City of Sacramento  
**Planning and Design Commission Report**  
915 I Street Sacramento, CA 95814  
www.cityofsacramento.org

**Florin Road Electric Fence (DR22-127) (Noticed 03/07/2023)**

File ID: 2023-00147

*Figure 1: Existing fence, Google Street View, Florin Road, 2022.*

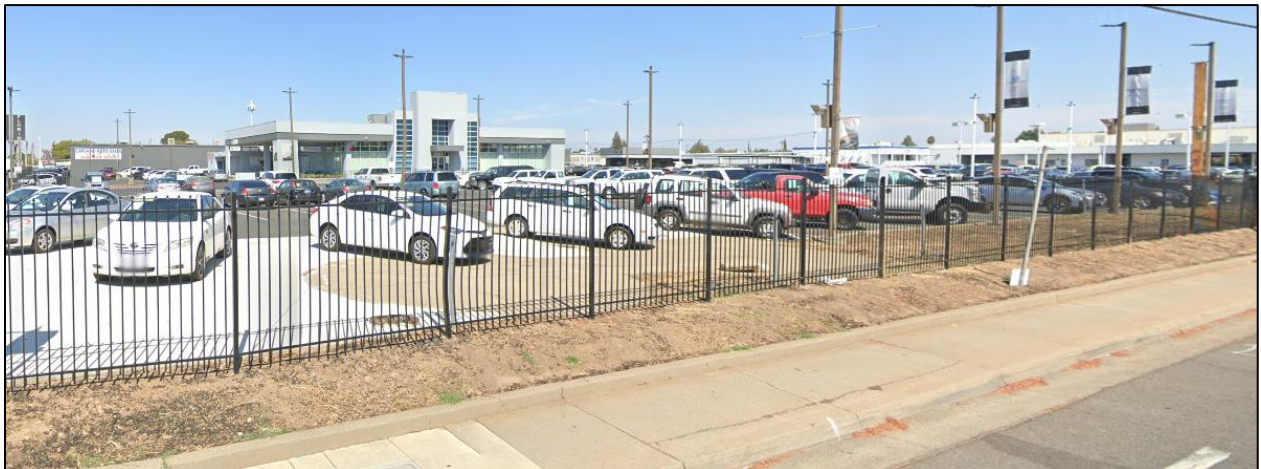
*The subject property currently has an existing wrought iron fence fronting Florin Road and a chain link fence with razor wire along Luther Drive. The proposed 10-foot high electric fence is a type that is capable of inflicting injury and is therefore considered to be “highly undesirable” by Design Guideline 21-6. The proposed project does not include any landscaping, screening, and is not visually appealing. The proposed fence does not enhance the character of the business corridor.*

Figure 2: Site Plan

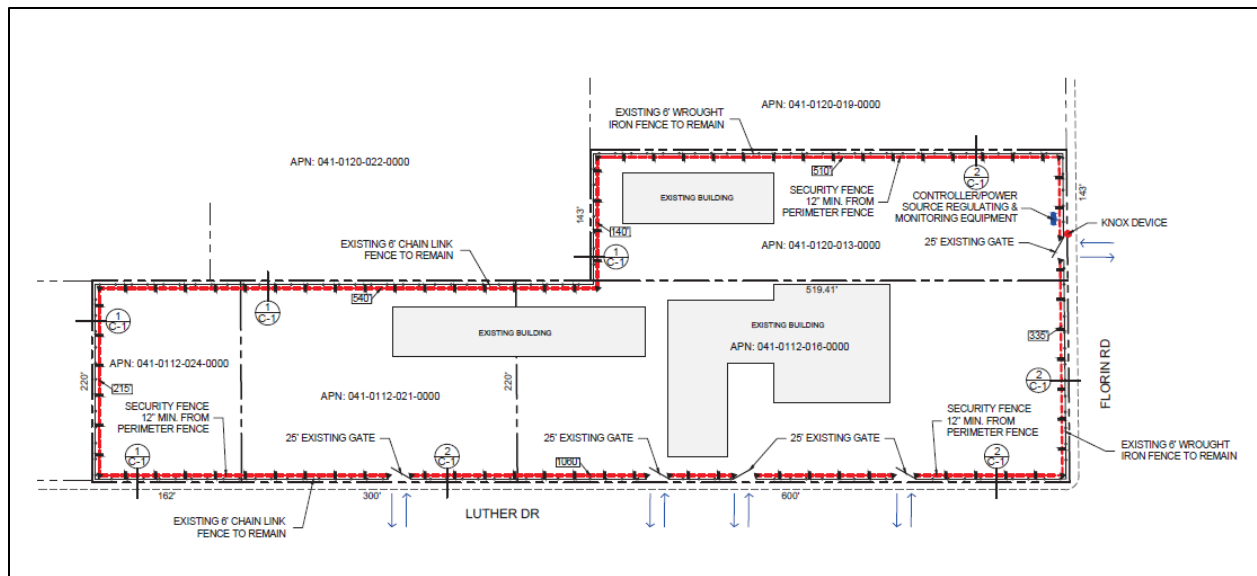
The applicant is requesting to install 2,753 lineal feet of 10-foot high, 12-volt electric fencing along the perimeter of four parcels. The electric fence is proposed one foot behind the existing six-foot high wrought iron fence and will include a woven wire fence between the existing fence and the proposed electric fence. The electric fencing is proposed along the front property line along Florin Road, the street-side property line along Luther Drive, the rear property line of two parcels, and the interior property line of three parcels.

The applicant is requesting a Site Plan and Design Review deviation to allow the installation of 12-volt electric fencing, a prohibited fencing material, along the front and street side property lines and within the front-yard and street side-yard setback areas, and within six-feet of the ground.

The proposed electric fence also includes woven wire mesh between the existing fence and the proposed electric fence. Woven wire is a prohibited fencing material in the C-1 and C-2 Zone along the front and street side property lines and within the front-yard and street side-yard setback areas and is not the subject of this deviation request.

**1 PERIMETER FENCE SECTION**  
NTS.

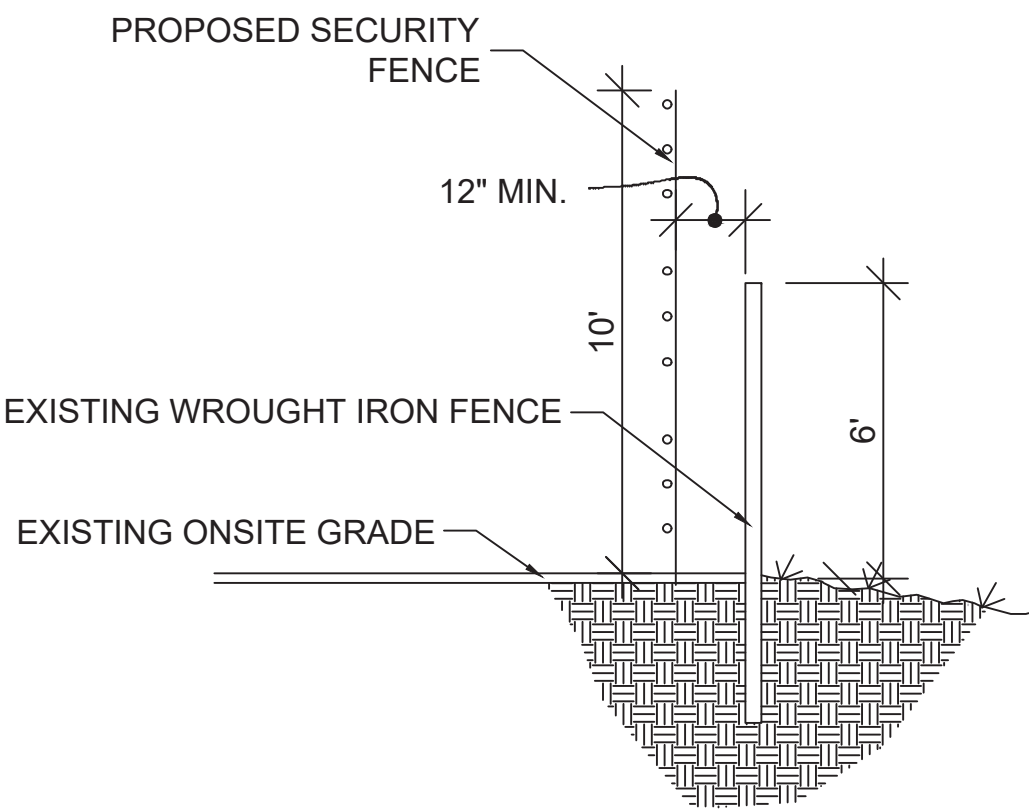
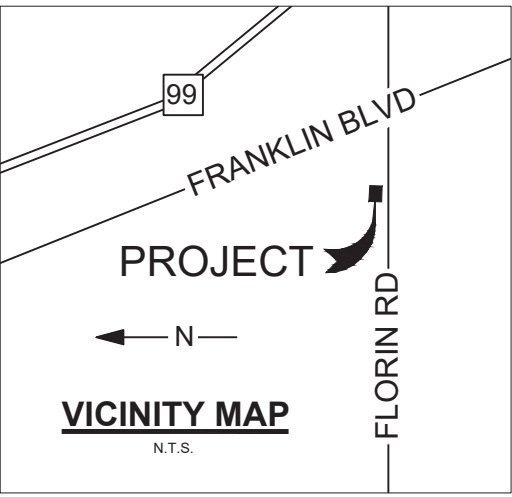
The electric fence, as proposed, would be hazardous to the public because the woven wire mesh, proposed to be located between the existing fencing and the proposed electric

fence, located one-foot behind it, is a prohibited fencing material. The electrified part of the fence is also located below six-feet in height. Without a sufficient barrier between the existing fence along the public street and the electrified fence, the electrified fence constitutes a safety hazard to members of the public conducting themselves in a lawful manner. The appellant has installed fencing at industrial locations as shown in Figure 3 below.
